Mission Park

Subdivision Land Use Application

RE: Mission Park Subdivision
FILE #: S-2016-001
Response for additional information - Completeness of Application

SHEET
P100
JOB NO.
2312-022

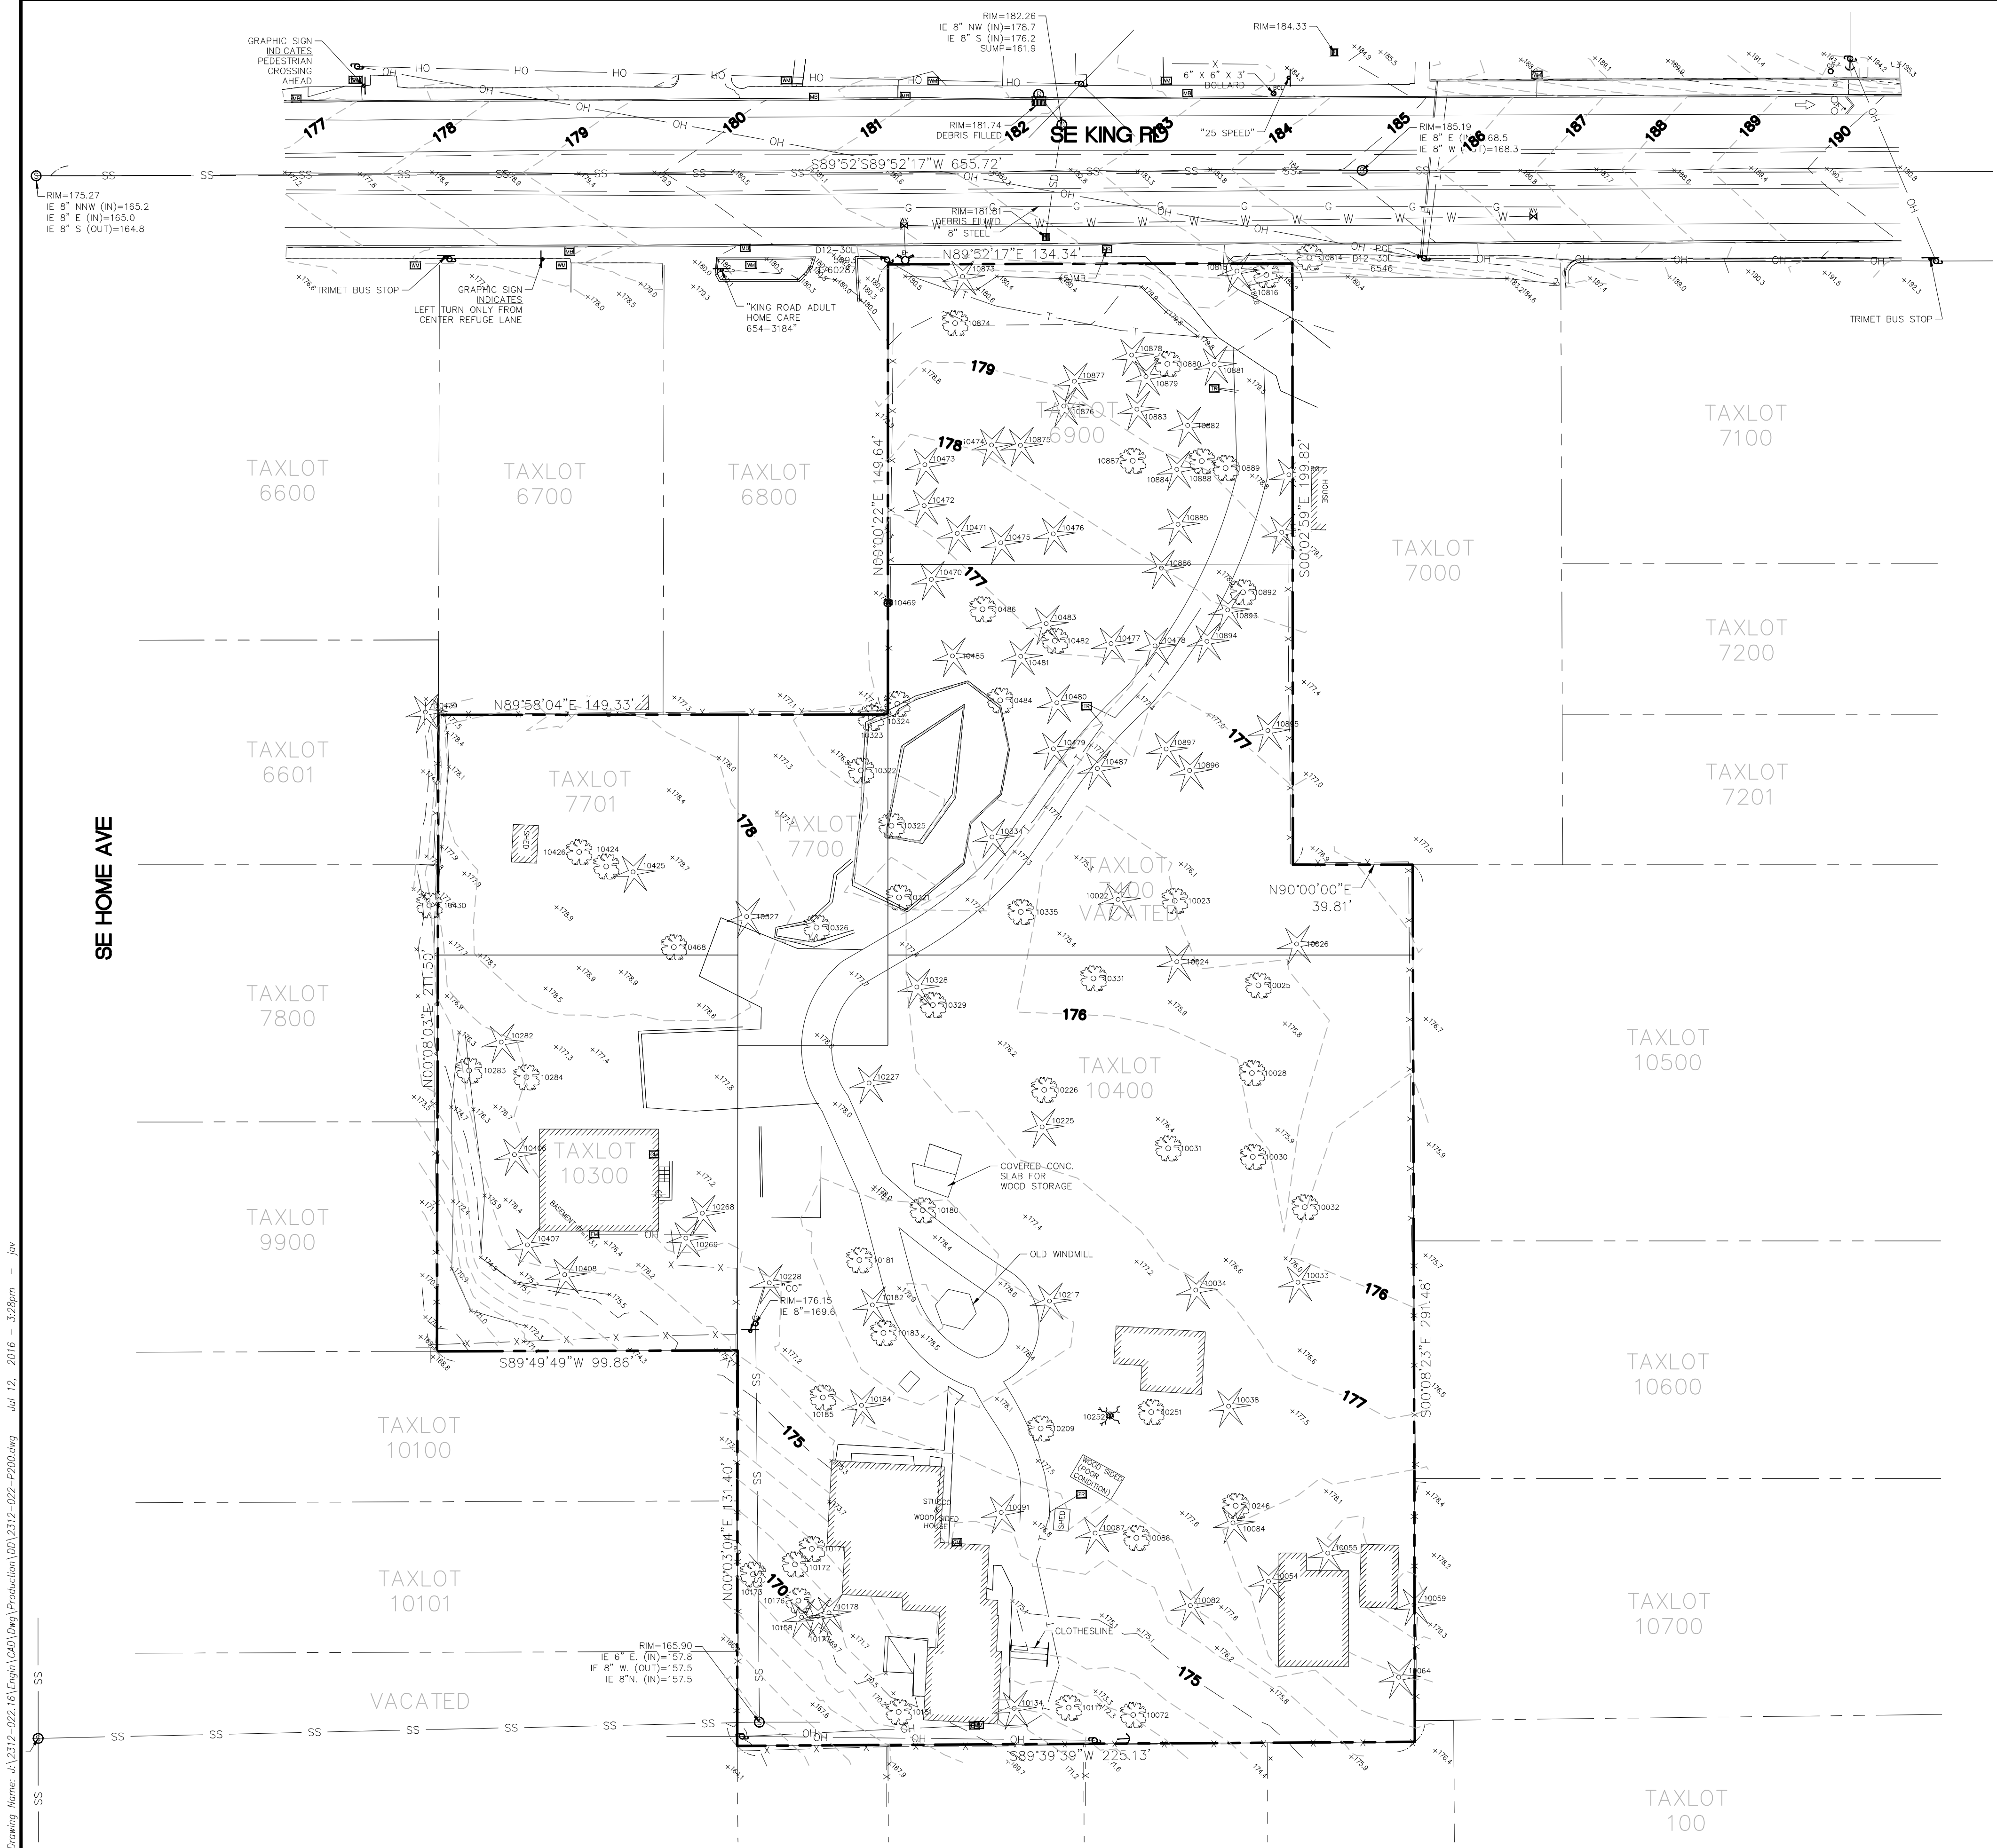
- a. *Sheet P100 of the submitted plan set denotes a different property owner than the owner listed on page 1 of the application narrative. Please revise the submittal so that this information is correct and consistent within the application sections.*

- c. *The preliminary plat as submitted (Sheet P300) does not include the location by section, township, and range and does not include a legal description as required. The property description noted on Sheet P100 identifies only tax map and lot information with 2 lots listed, whereas 6 lots are the extent of the property.*

Response: Sheet P100 of the preliminary engineering plan set and the application narrative have both been revised to reflect consistent property owner information.

Response: Sheet P300 of the preliminary engineering plan set has been revised to include the subject property location by section, township, and range, as well as a legal description. Sheet P100 has been revised to reflect the appropriate property description.

REVISIONS SHEET **P200**
 JOB NO. 2312-022
 COPYRIGHT © 2016

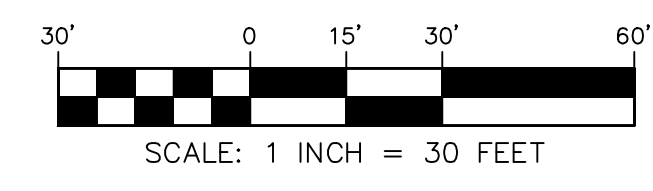
- d. *Contour lines with intervals at a minimum of 2 feet for slopes up to 10 percent and 5 feet for slopes over 10 percent have not been included on the existing conditions plan (Sheet P200); only spot elevations have been included on this sheet.*

Response: Sheet P200 of the preliminary engineering plan set has been revised to reflect contour lines with intervals at a minimum of 2 feet for slopes up to 10 percent and 5 feet for slopes over 10 percent.

SHEET
P300
JOB NO.
2312-022

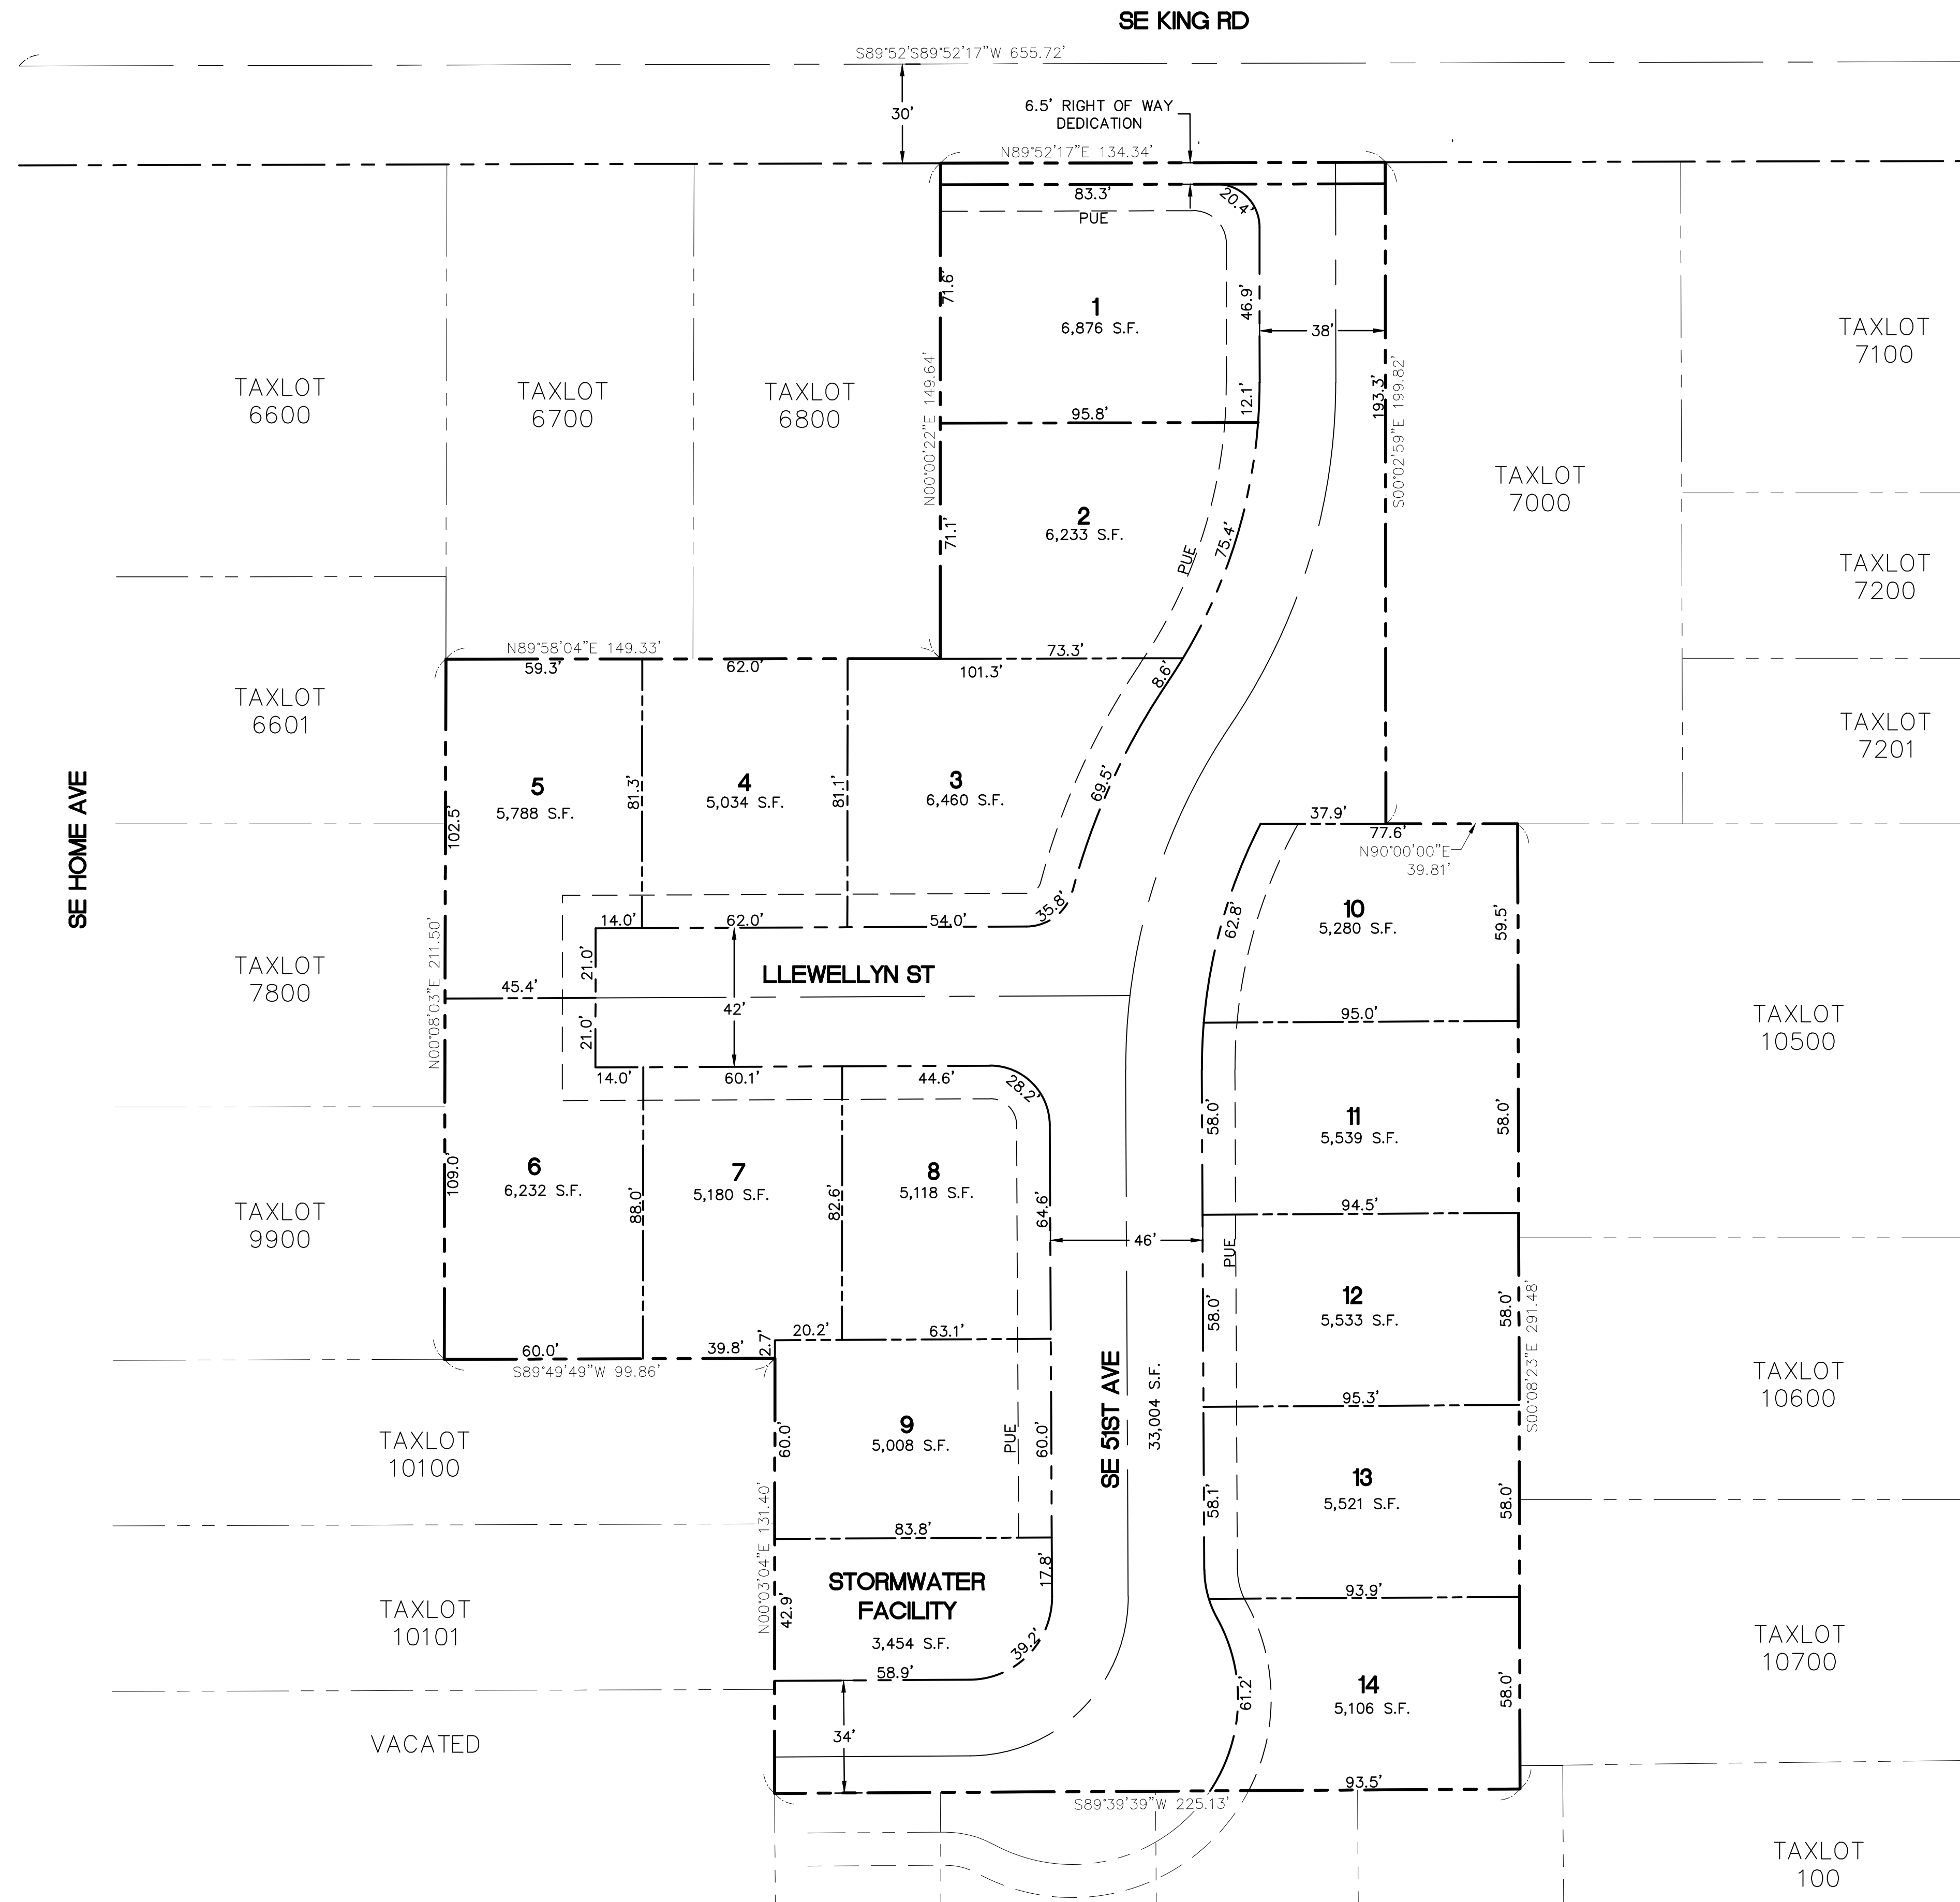
- b. *The preliminary plat as submitted (Sheet P300) has not been stamped by an Oregon registered land surveyor as required.*
Response: Sheet P300 of the preliminary engineering plan set has been stamped by an Oregon registered land surveyor.

- e. *The preliminary plat as submitted (Sheet P300) identifies Tract A (1,272 SF): what is the purpose of Tract A? Information regarding its use, ownership, etc. does not appear to be included.*

Response: Sheet P300 of the preliminary engineering plan set has been revised to reflect a public right-of-way dedication of 1,272 S. F. previously labeled Tract A.
